# Town of Clifton Park

## PLANNING BOARD

Those present at the February 8, 2011 Planning Board meeting were:

[2010-043] **Ellis Hospital Extension** – Proposed construction of 39,000 sq/ft Satellite Emergency Clinic, 103 Sitterly Road, Preliminary site plan review SBL: 272.-1-40.1

**409 Clifton Park, Saratoga Springs**

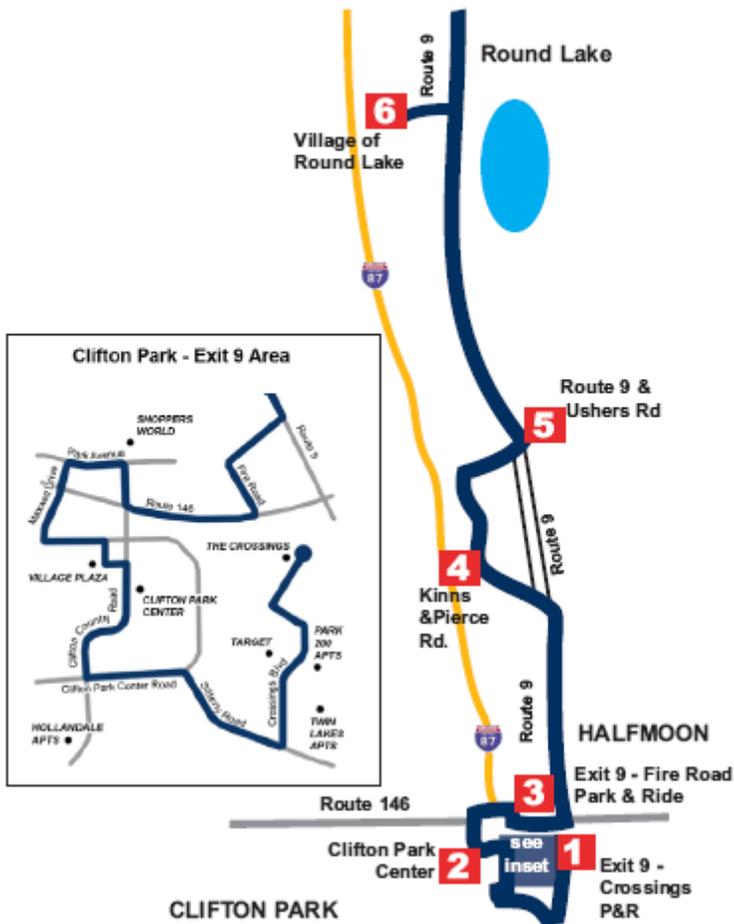
**Bus Route/Bus Stop and Bus Pull-off Area.** The traffic study should also take into account, as well as the site plan configuration for pedestrian circulation, that the CDTA is operating a Route 409 Bus Service (Clifton Park, Malta, Saratoga

Springs) along this project site, along Sitterly Road and Clifton Park Center Road. The site plan should identify and note the bus route. The presence of Ellis Hospital would be expected to generate bus riders coming to and from the project site – by employees. The applicant should be in consultation with CDTA for ensuring an accessible bus stop to serve this project site. With the presence of a significant public right-of-way near the location of where the “trail” ends at Old Sitterly Road, this area could be the location for a bus stop/bus pull-off area. Also, see below comments for this location for a crosswalk across Sitterly Road to the south side of Clifton Park Center Road. Below is the bus route.
